SUBDIVISION REVIEW SHEET

CASE NO.: C8J-2022-0030.1A

SUBDIVISION NAME: East Village RA – 18 & 22

**CITY OF AUSTIN – TRAVIS COUNTY – SINGLE SUBDIVISION OFFICE
SUBDIVISION APPLICATION – MASTER COMMENT REPORT**

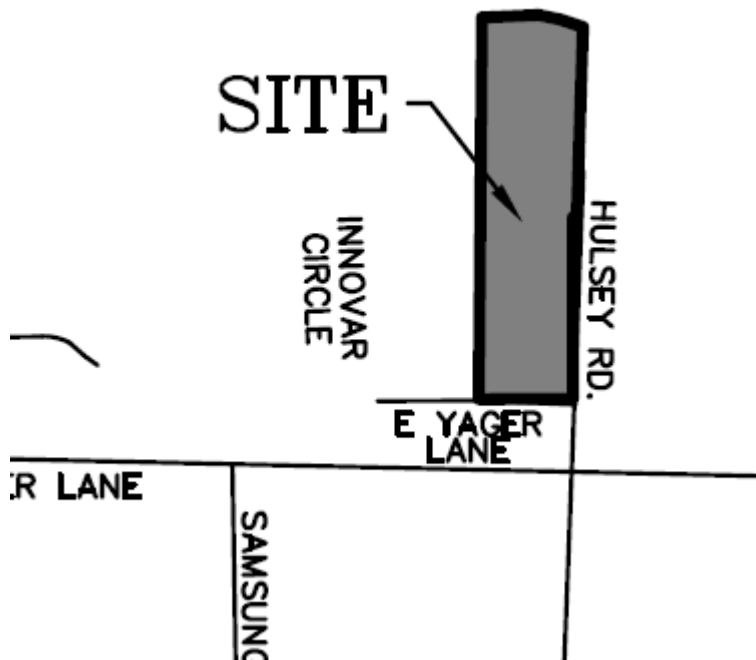
AD2: Please add the label HULSEY RD and indicate on whether it is a ROW dedication on sheet 1 and 2 as shown on the image below

SHEET 2
MATCH LINE SHEET 1

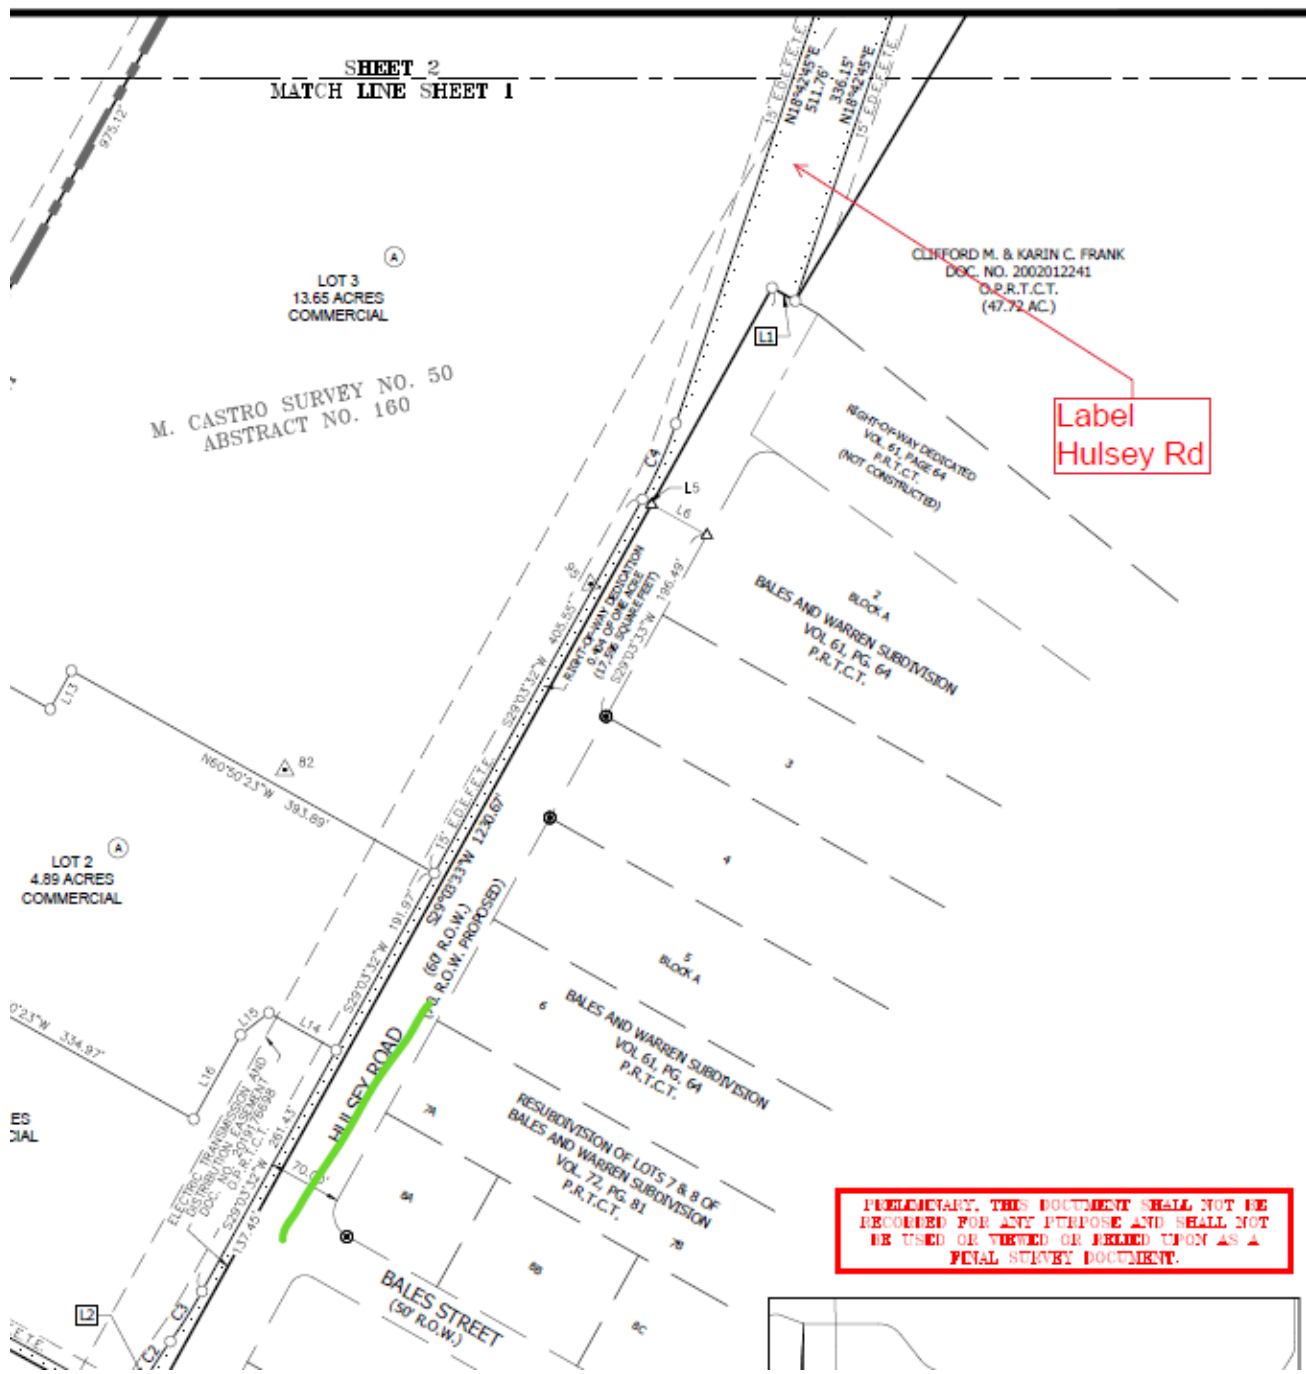
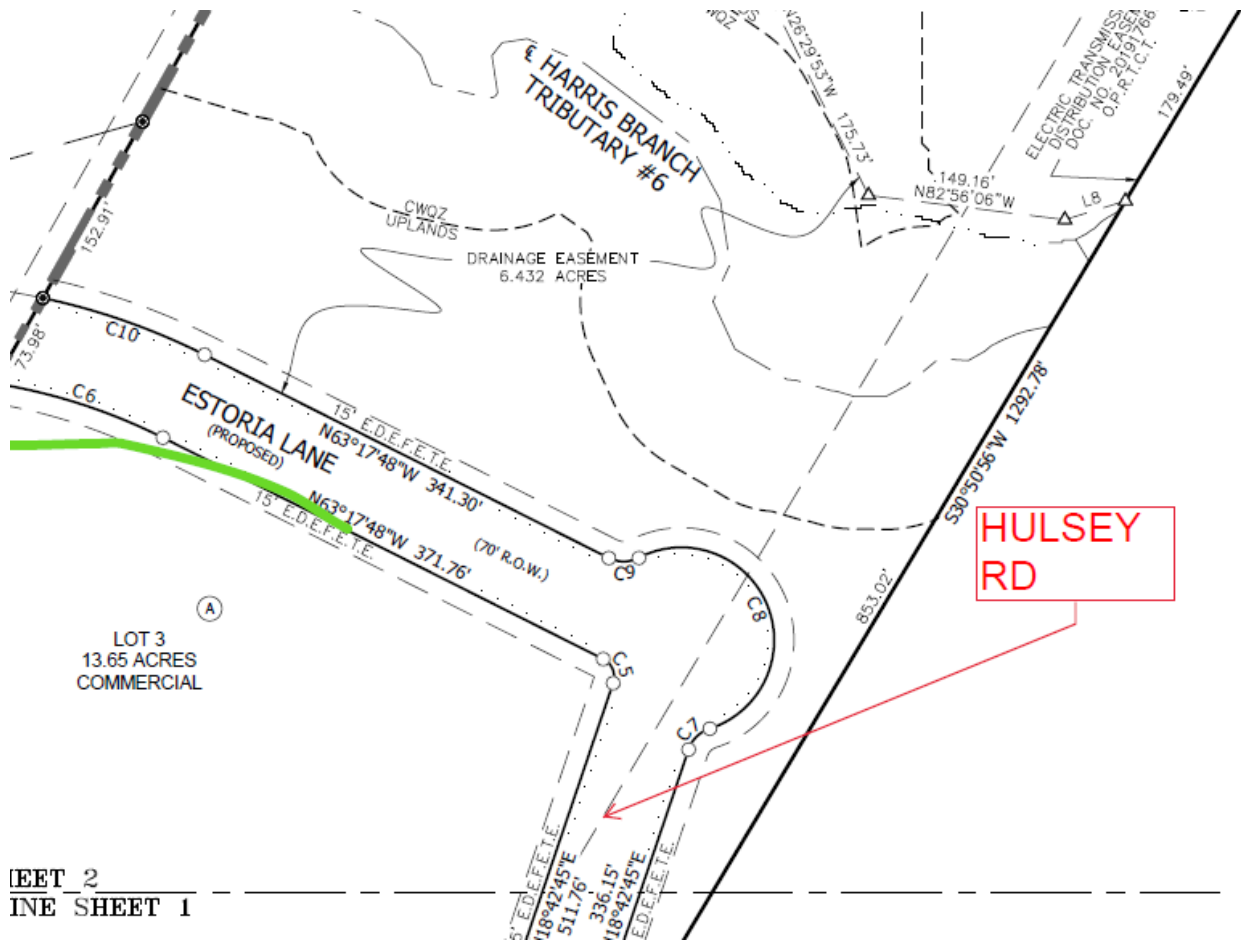
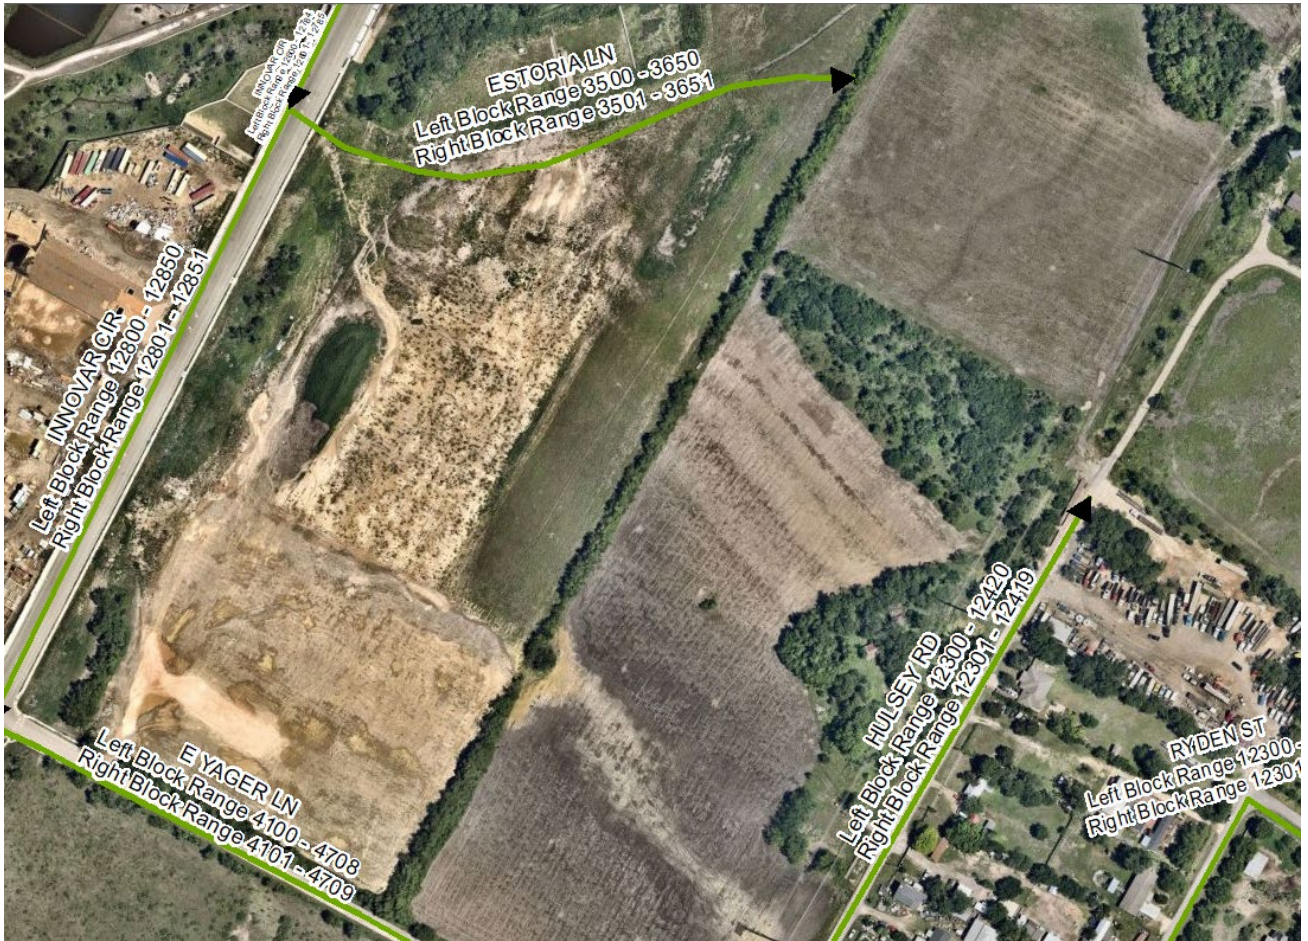
AD3: Please remove all forms of punctuation after abbreviating street types or directionals from the vicinity map

AD4: Please remove the label INNOVAR CIR since there is no street centerline represented on the vicinity map

Label
Hulsey Rd
